March 7, 2018

**Re: 2018 Technical Work Plan and Schedule
Upland Landfill
Upland Excavating, Campbell River, British Columbia**

Table 1
Clarification Table - Meeting February 15, 2018
2018 Technical Work Plan and Schedule
Uplands Landfill
Upland Excavating, Campbell River, BC

Figure 1 Base liner system with leak detection layer schematic

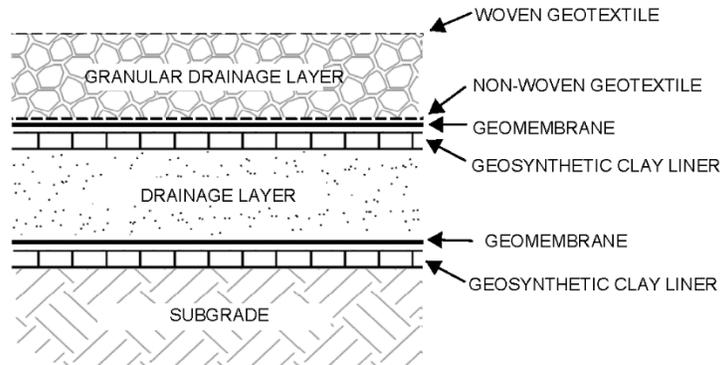
5	3	2	A liner leak detection system should be installed for the new landfill cell. Such a system would facilitate early leak detection beneath the landfill liner. Given the site hydrogeology, detection of leakage via proximal monitoring wells should not be exclusively relied upon for detection of liner leaks.	"The migration potential and degree of transport attenuation for these constituents in groundwater varies based on a number of factors. However, under conditions of high groundwater velocity such as those at the Site, the potential for off-site impact is significant in the event of a breach in the landfill liner system. In that even, the impact would be difficult to control and remediate."	Please elaborate on the need for a leak detection system as it is not typical in non-haz landfills in NA Due to the high groundwater velocity, it is true that impact would be difficult to control. However, potential low-level impacts will be subject to high levels of dilution and attenuation prior to reaching off-site. A leak detection system is suggested as a contingency measure. Leak detection systems are not normally required for non-haz landfills in NA jurisdictions. Leak detection system previously identified as a contingency measure May 15, 2017 meeting	ENV asked if the leak detection system is going to be proposed. Client Group advised leak detection system is being considered as per ENV recommendation. A leak detection system is above and beyond the requirement for a non-hazardous solid waste landfills. ENV clarified the leak detection system is being recommended as it may have the potential to satisfy public concern. GHD identified that an integrated contingency plan that can include trigger level programs and increased frequency in phased capping and/or complete capping of the landfill.	Client Group to consider inclusion of leak detection system. GHD to provide detail on other contingency measures that would either integrate with or be in place of a leak detection system for ENV review and consideration. The framework of the integrated contingency plan to be reviewed at Feb 26, 2018 meeting

GHD will prepare the design of the leak detection system and a protocol for determining the location of the leakage through the primary liner should it occur. The leak detection system will be installed beneath the base of the landfill and leachate treatment pond. Figure 1 provides a conceptual schematic of the leak detection system design, which will consist of a sand drainage layer below the primary composite liner system. The secondary liner system beneath the sand drainage layer will include a 1.5 millimetre (mm) HDPE geomembrane and a geosynthetic clay liner (GCL).

In the event of primary liner leakage, leachate will be collected and conveyed in sand drainage layer to perforated collection piping. The leachate will be contained by secondary liner system.
